METROPOLITAN GOVERNMENT OF NASHVILLE AND DAVIDSON COUNTY

STAFF RECOMMENDATION
3105 Overlook Drive
October 15, 2014

Application: New construction—addition.
District: Hillsboro-West End Neighborhood Conservation Zoning Overlay
Council District: 18
Map and Parcel Number: 10410020600
Applicant: Van Pond, Architect
Project Lead: Melissa Baldock, melissa.baldock@nashville.gov

<p>Description of Project: Application is to construct a new front dormer and a side and rear addition.</p> <p>Recommendation Summary: Staff recommends disapproval of the project, finding that the dormer and the side addition do not meet Sections II.B.1.a., b., e., f., and j. and II.B.2. of the <i>Hillsboro-West End Neighborhood Conservation Zoning Overlay: Handbook and Design Guidelines</i>.</p> <p><i>Staff does not recommend approval with conditions since a redesign is likely necessary to meet the design guidelines. If disapproved, the applicant may return with a new design.</i></p>	<p>Attachments A: Photographs B: Site Plan C: Elevations</p>
---	---

Figure 3. This 1968 photo shows the side extension as a breezeway and one-car garage

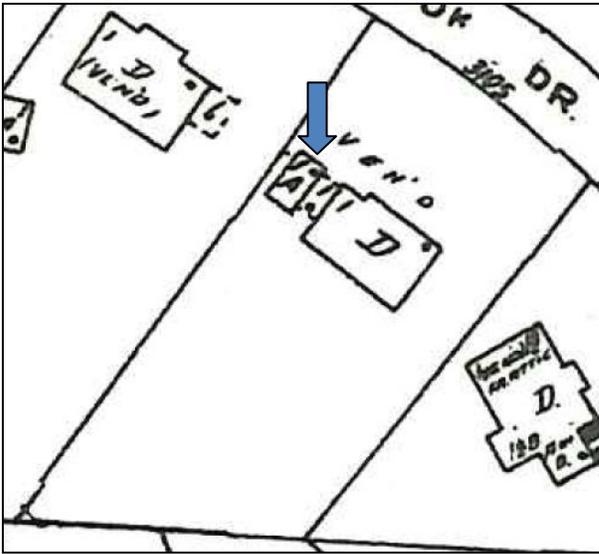
3105 Overlook Avenue is located on a steeply sloped lot. To the right side of the main form of the house is a one-story side extension (Figure 2). This extension may be original to the house, as it appears in the 1957 Sanborn map (Figure 3), but not in its current design. The Sanborn map and a photo from 1968 indicate that originally the extension was an open breezeway that connected the house to a one-story, one-bay garage (Figure 4). In 1999, the breezeway and garage were altered and became enclosed, conditioned space.

Proposed Front Elevation
1/8"=1'-0"

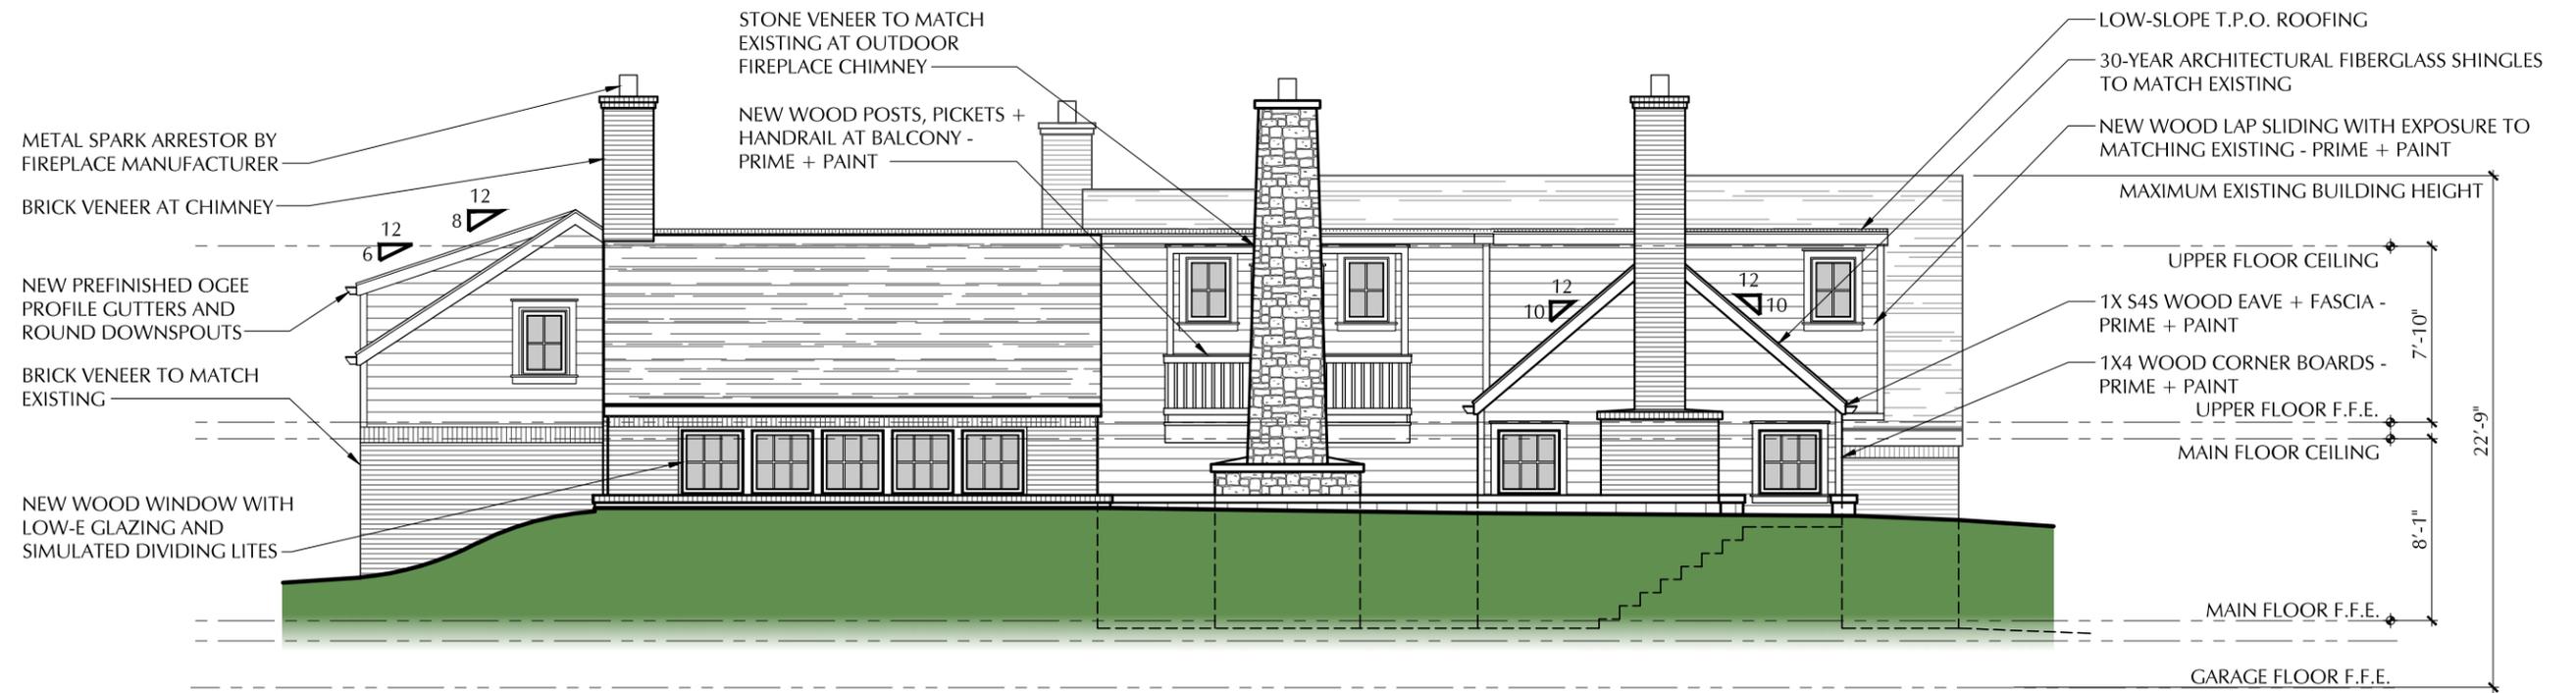
The proposed central front dormer likewise does not meet the design guidelines for additions. The design guidelines state that conjectural architectural elements are not to be added because they create a false sense of history. In the past, the Commission has allowed new rear and side dormers, but has not allowed front dormers unless one was formerly in the same location. The applicant is proposing to construct a third, central dormer to the front façade, when there is no evidence that such a dormer ever existed. The two gabled dormers on either side of the central doorway is a typical Cape Cod house configuration, and the proposed third, central dormer interrupts this original form. Because a third, central dormer never existed on this house, adding one to the front does not meet the design guidelines.

Roof form: The applicant proposes to construct a new front dormer, centrally located between the two existing front dormers. The new dormer will match the size and form of the existing dormers. Nevertheless, there is no evidence that a third, central dormer existed on the front slope of the roof, and staff therefore finds that the front dormer does not meet the design guidelines.

The second story addition on top of the existing side extension will have a side-gabled roof form. A shed dormer that is set back at least two feet (2') from the wall below will be added over this portion of the house. Although these roof forms can be appropriate in some instances, in this case, the added roof space alters the scale of the historic house in a manner that does not meet the design guidelines.

The extended side addition will have a front facing gable, making it a two-story form. This does not meet the design guidelines, which states that side additions should have a side gabled or hipped roof form. On the right side of the side extension, the application is proposing a wall dormer. The Commission has in the past required that dormers be set a minimum of two feet (2') off the wall below on side facades, and has disapproved wall

Orientation: The proposed addition alters the orientation of the house inappropriately by detracting from the current primary entrance on the Cape Cod portion of the house. Currently, there is an existing secondary entrance on the existing side extension, where there was formerly an open breezeway. Although the size of this secondary entrance will not change, the addition of a second level over the existing extension and a new two-story side addition give more prominence to this secondary entryway. Because of the scale of the addition is so large, the secondary entrance appears to be a primary entrance to a separate house attached to the Cape Cod house.

The new walled terrace proposed for the front of the house further detracts from the existing primary entrance on the Cape Cod portion of the house. Currently, the primary entrance is accessed via an uncovered stoop directly in front of it. The walled terrace will close off direct access to the primary entrance; the terrace ensures that the primary entrance can only be accessed by ascending the steps in front of the secondary entrance, and then walking along the terrace to the primary entrance. This will make what should be the secondary entrance too prominent.

Appurtenances The existing driveway will be retained as part of this application. As discussed under the “Orientation” section, the proposed walled terrace at the front of the house does not meet the design guidelines. It will be approximately ten feet (10’) deep and will cover most the Cape Cod portion of the house and part of the existing extension. It will be four feet (4’) tall and largely solid in nature. It adds a conjectural feature to the house, and obscures significant architectural features of the Cape Cod’s front façade. In addition, it alters the perceived orientation of the historic house by minimizing the primary entrance and giving more prominence to the secondary entrance.

Proposed Rear Elevation
1/8"=1'-0"

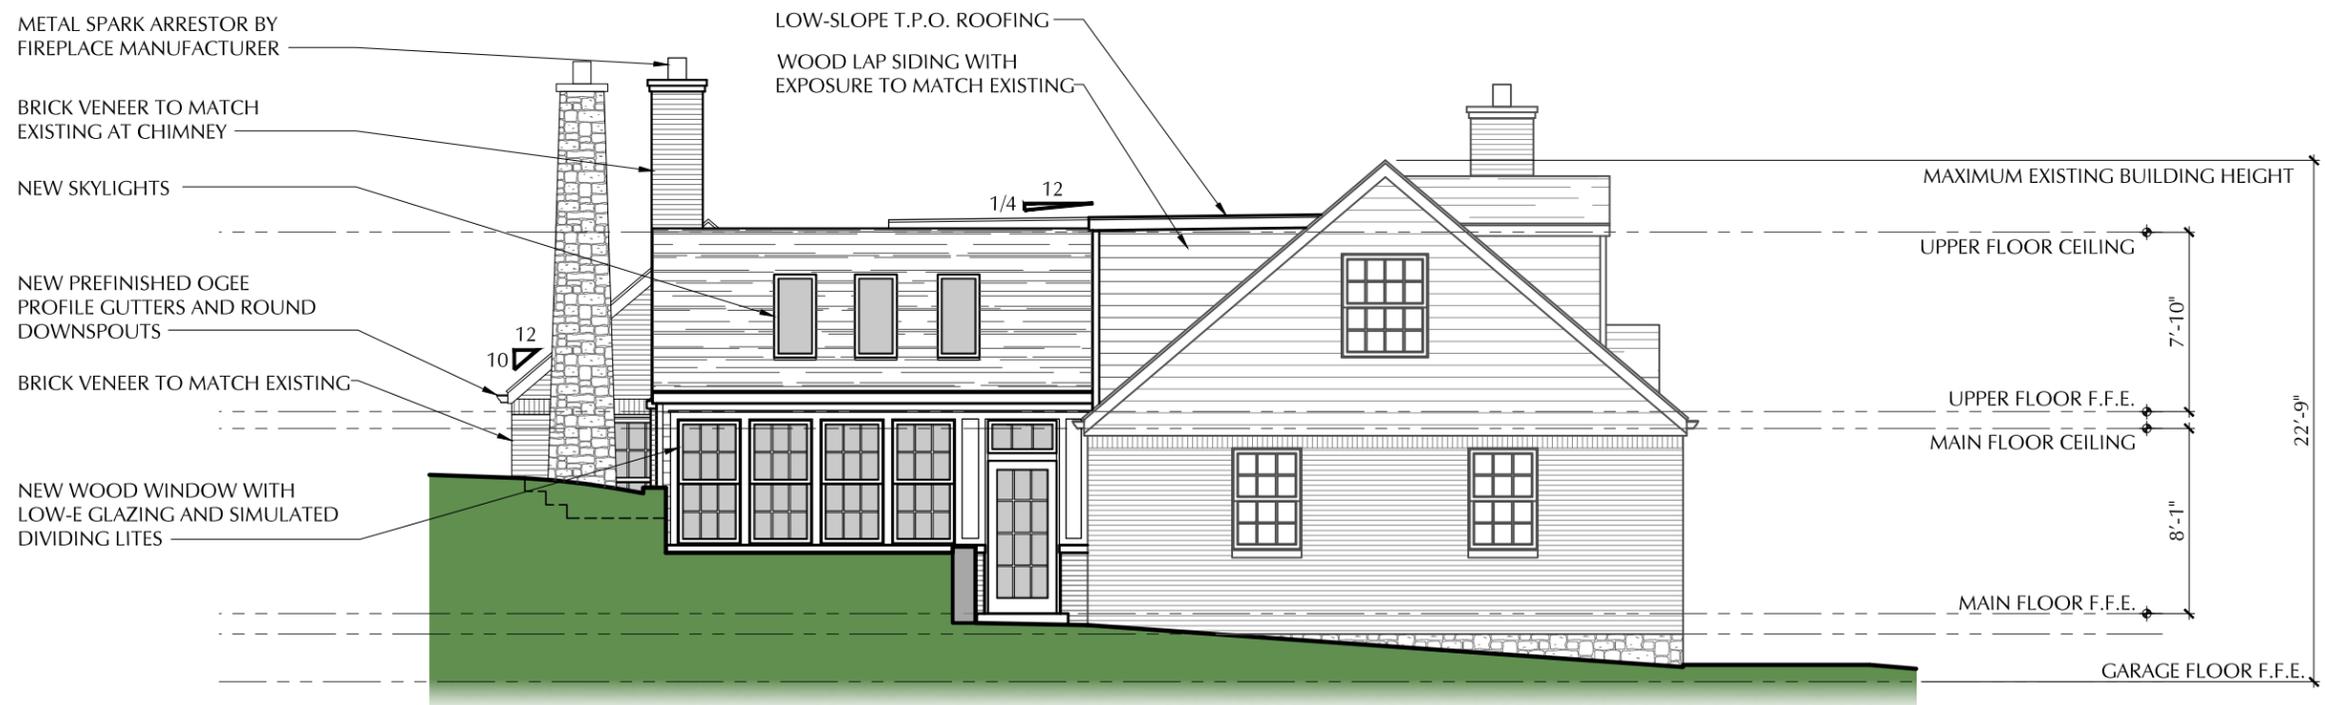
The proposed rear addition steps in approximately five feet (5') from the historic house on the left side. On the right side, the rear addition wraps the right corner of the existing house and becomes part of the side addition. Typically, the Commission has asked that rear and side additions preserve the back corners of the house in order to retain the original form of the house. However, in this instance, staff finds the wrapping of the back right corner to be acceptable because this portion of the house was part of the garage extension and not part of the main Cape Cod house form. The rear portion of the addition will be approximately two feet, six inches (2'6") lower in height than the Cape Cod portion of the house, which is appropriate. It will have a maximum width of sixty-six feet (66') and a maximum depth of approximately twenty-three feet (23'). Although the rear addition portion of the project meets the design guidelines for height and scale, staff finds that overall, the project does not meet Sections II.B.1.a. and b. and II.B.2. of the

The rear addition involves removing an existing rear shed dormer and constructing a new shed dormer. The new shed dormer will step in from the left side wall of the house by over three feet (3') and will continue the width of the back of the existing house. It will have a low slope, nearly flat roof form, which is appropriate since it will likely not be visible from the street. Other portions of the rear addition included gabled forms with slopes ranging from 8/12 to 10/12.
